DM/22/03778/FPA: development of 368 dwellings, associated access and works, and demolition of former farm buildings (resubmission) (further information).

The City of Durham Trust welcomes the opportunity to comment on the package of documents recently submitted as "further information" for the above application.

The following excerpt from the Adoptable Highways Plan illustrates a number of design deficiencies:

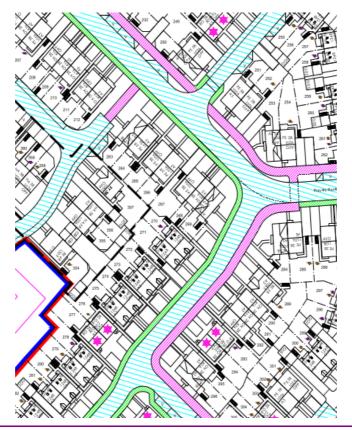
- The short cycleway (shown in pink) near the top of the excerpt links the housing which is accessed from the Fire Station turning on the A691 to the rest of the site. The verge and visitor parking space prevent users joining the main cycleway on the other side of the road.

- 2. Where the main cycleway crosses the cul-de-sac the cycleway surface ends. The latest edition of the Highway Code advises that vehicles should give way to pedestrians and cyclists crossing side roads. Among the KDPs are recommendations for raised entry treatments and continuous footways. Such treatments would help to "give priority first to pedestrian and cycle movements" in accordance with NPPF paragraph 112 and reinforce observance of the Highway Code.

- 3. The KDPs recommend tightening side road radii in order to reduce entry/exit speeds. The radius shown here appears to be 6.0m which comes from guidance which is now outdated. *Manual for Streets 2*, para. 9.4.10 states that "advice contained in TD 42/95, that minimum corner radii should be 6m in urban areas, should therefore not be taken as best practice when the needs of vulnerable road users are to be prioritised". Tight corner radii are recommended by LTN 1/20 in paras. 7.6.10 and 10.5.4. Paragraph 10.5.16 suggests corner radii of preferably no more than 4.0m.

- 4. The excerpt shows both the cycleway and the footway (shown in green) on the opposite side passing a large number of driveways. Both abut the carriageway. Typical street construction over the last few decades has the footway sloping towards the carriageway whenever a drive is crossed. This creates an undulating surface which is harder to use with wheeled equipment such as buggies, wheelchairs and cycles, and can be dangerous on foot in icy conditions. The DCC Residential Design Guide asks for a minimum width of 800mm at the back of the footway with crossfall of no more than 1:40. There is no DCC guidance given for cycleways. As the cycleway is 3.0m wide, the Trust suggests that at least 2.0m of the width should have the crossfall limited to 1:40. This could be secured by applying a condition.

- 5. Where the cycleway abuts the carriageway, if the kerb is the normal height then Table 5-3 of LTN 1/20 would require an additional 200mm width to maintain the effective width of the cycleway. This has not been provided.
